**ROYAL VANCOUVER YACHT CLUB:
ADDITIONAL VIEW AND SHADE ILLUSTRATIONS**

TECHNICAL MEMORANDUM

To:	Emily Williamson (VFPA)	From:	Russ Tyson
cc:	Chris Barnett (RVYC Asset Manager)	Date:	February 10, 2020
Subject:	Construction Staging Plan	Project No:	17-113

VIEW **A** LOOKING NORTH/EAST
FROM WESTIN DAYSHORE AT THE LIFT RESTAURANT
NOTE: PROPOSED 'K' FLOAT AND BOAT'S NOT SHOWN.

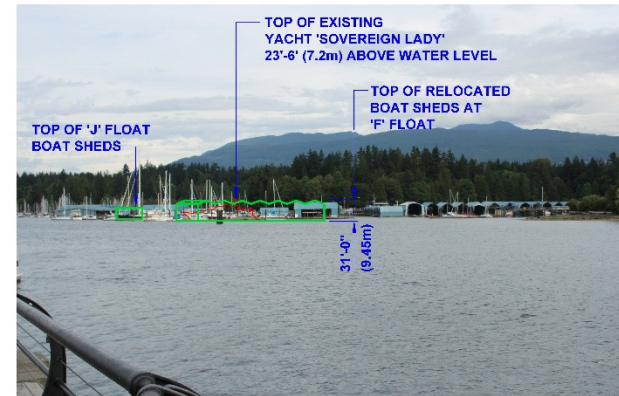
The expansion of the marina and the construction of K float relative to the Lift Restaurant might offer an improvement from a view perspective, as the existing views of boat sheds will be replaced by views of power- and sailboats moored to the southern portion of K float.

VIEW **B** LOOKING NORTH/WEST
FROM LIGHTSHED SCULPTURE.

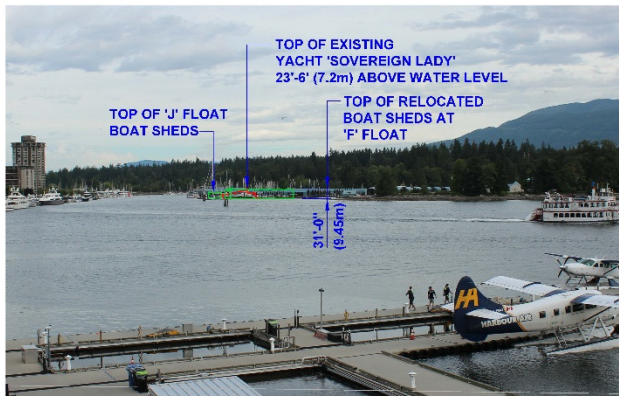
As illustrated below, due to the relatively localized nature of Coal Harbour marina and the fact that the project involves the replacement of the boat sheds that are essentially the same size, colour, height, and width of existing boat sheds, limited impacts are anticipated to occur. Shade will not be an issue to the surrounding community, as the boat sheds, sailboats, and motorboat superstructures, are of similar height.
